February 5, 2018

Re: Comments on the Draft Environmental Impact Statement/Environmental Impact Report for the Ballona Wetlands Restoration Project; Support of Alternative 1 with modifications

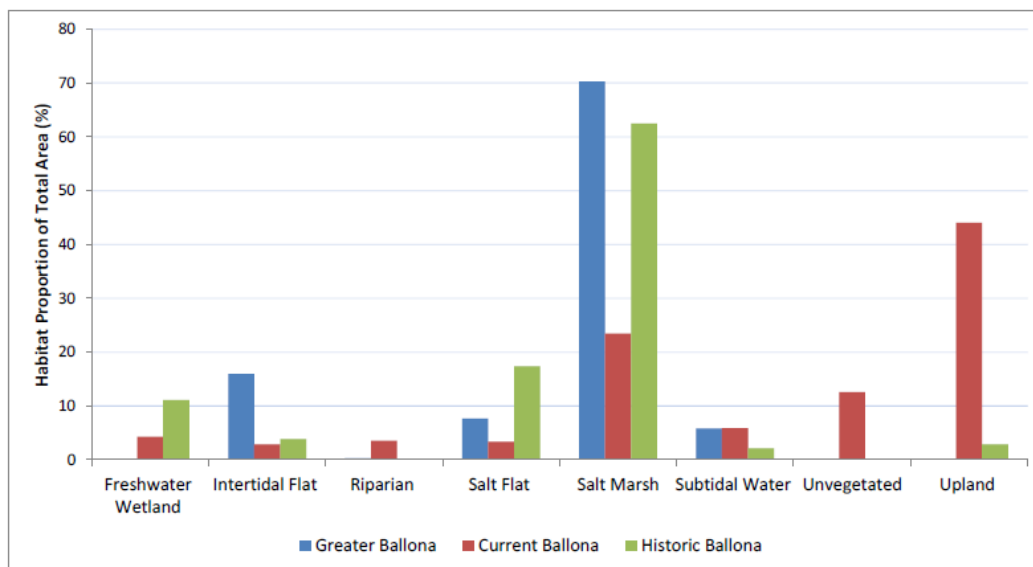
given current infrastructure. Therefore, given current constraints and feasibility issues, future sea level rise, and historical ecology evidence, moving forward with a restoration that emphasizes estuarine tidal wetlands is the best option.
